SOUTH WRAXALL MANOR Studio

Block & Roof Plan
as Proposed

1084.P.001

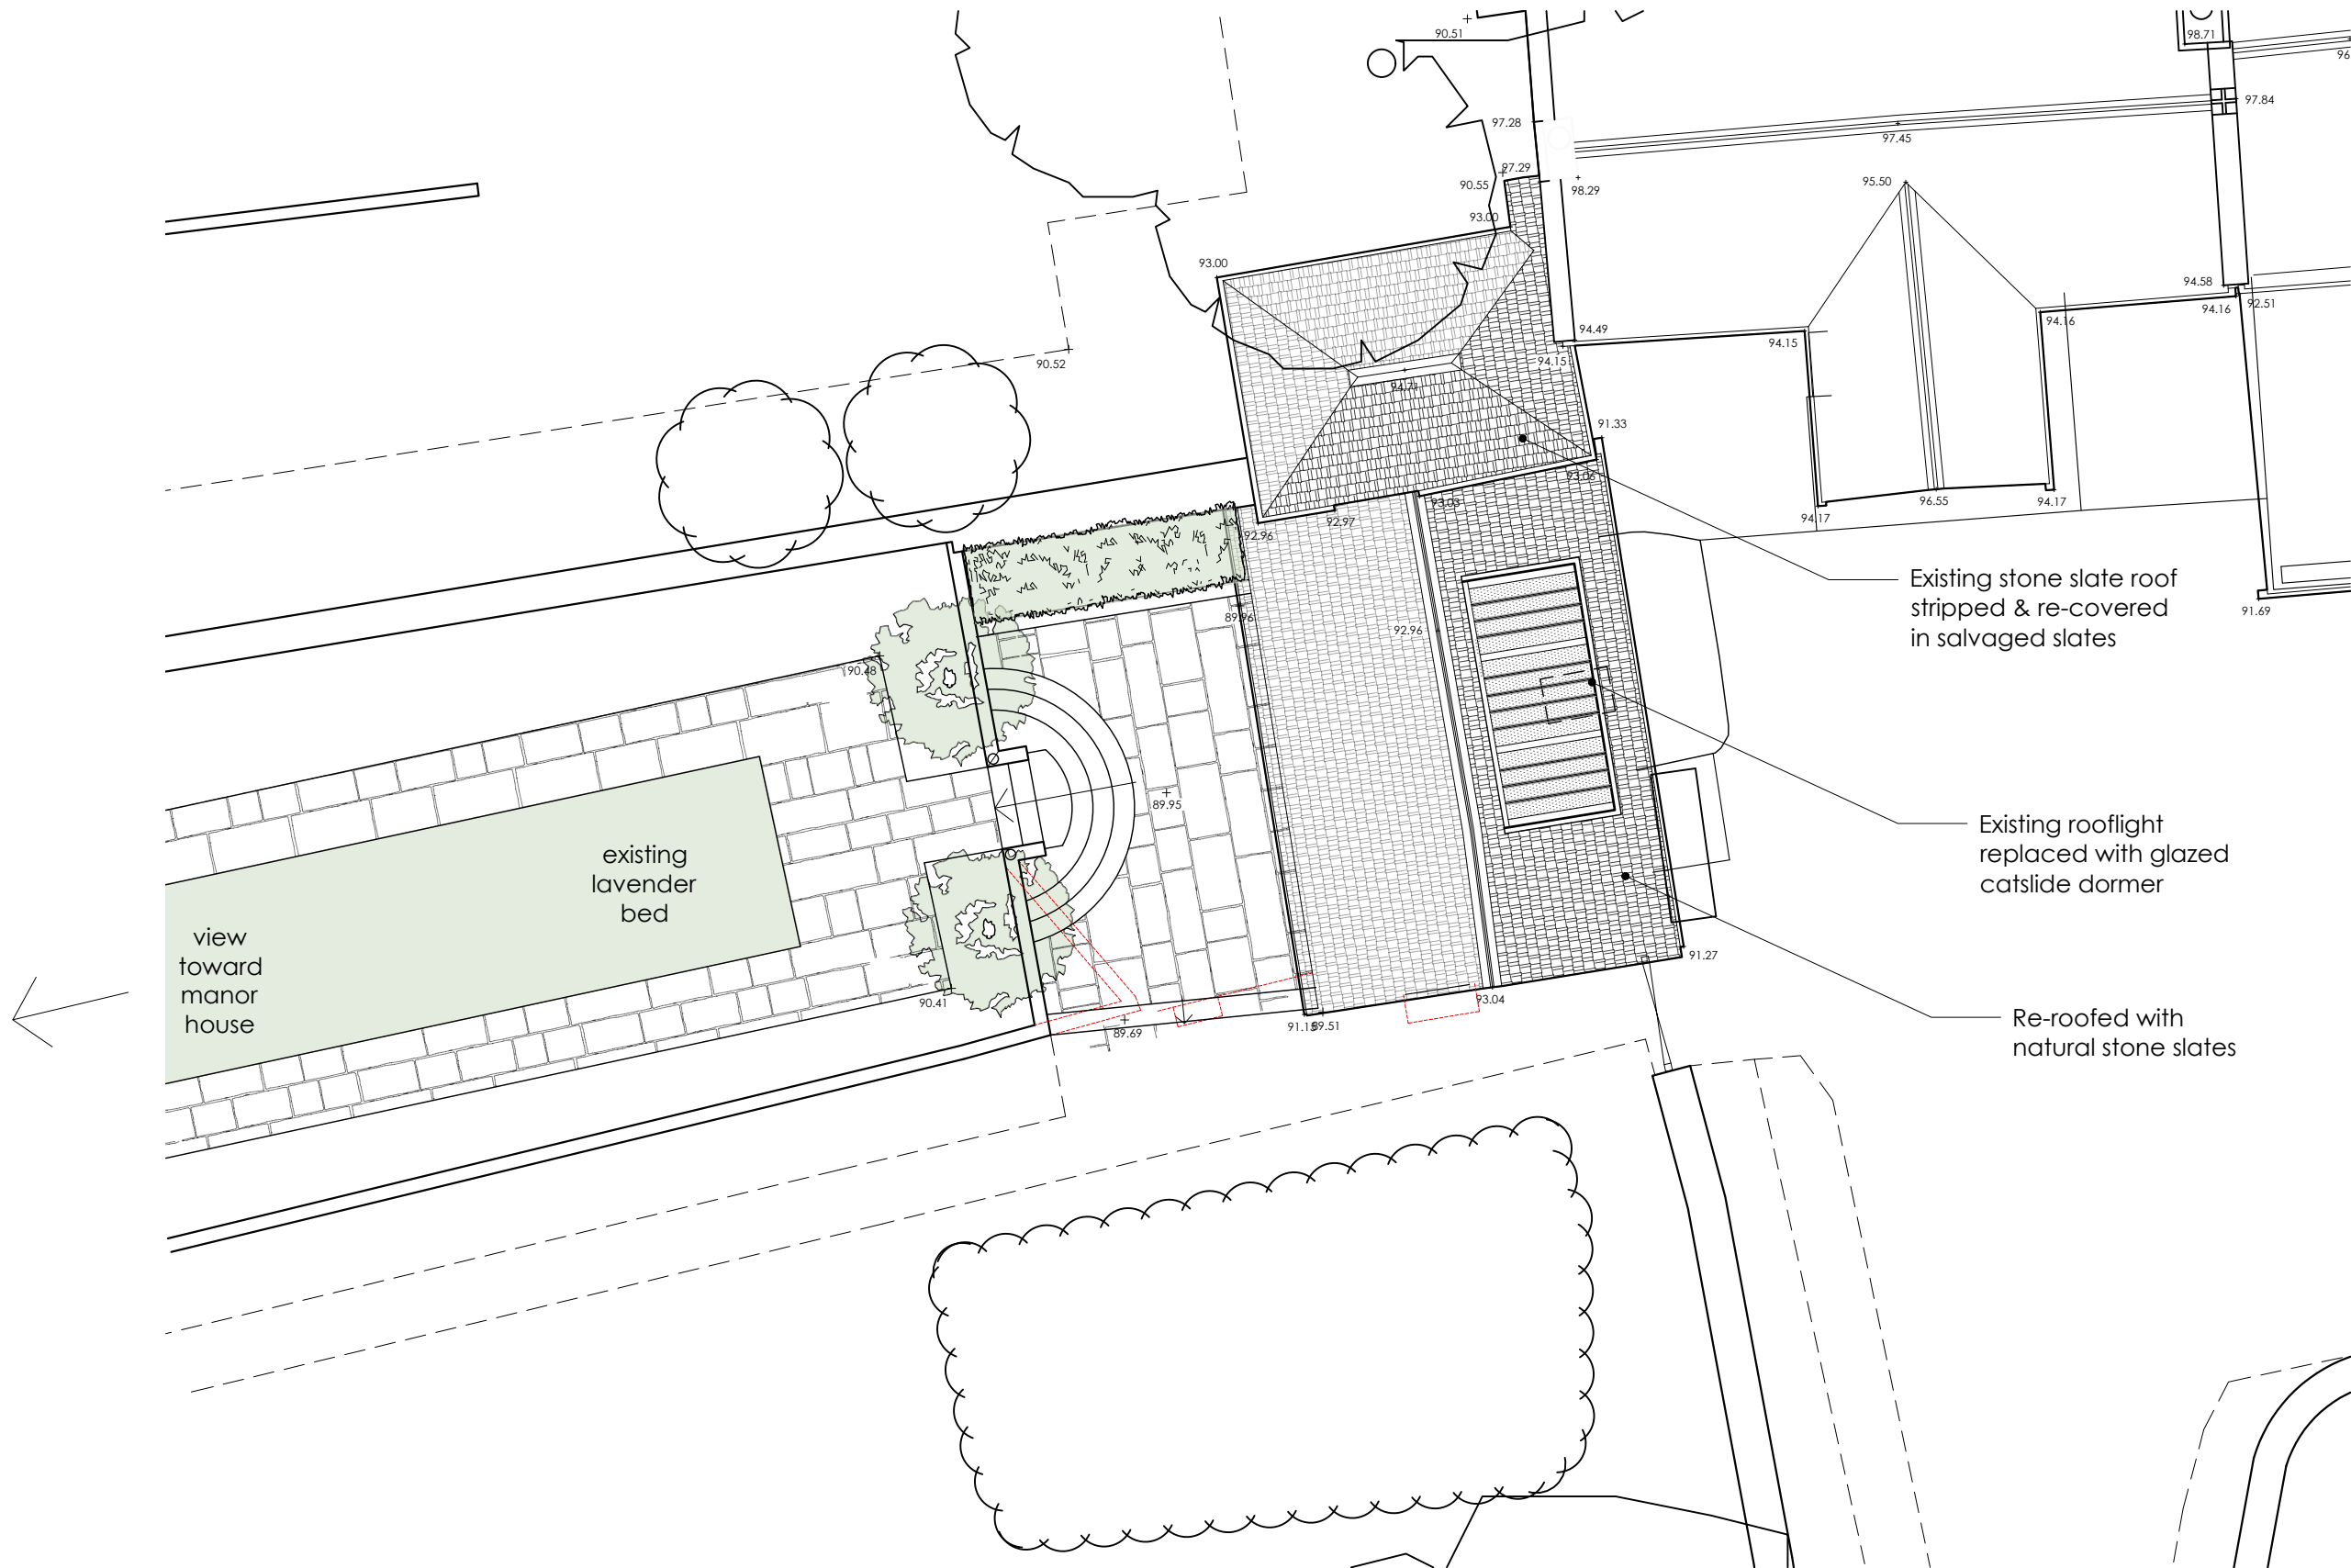
A	21.08.2028	SA	Steps omitted, door revised to window
Revision	Date	Initials	Notes
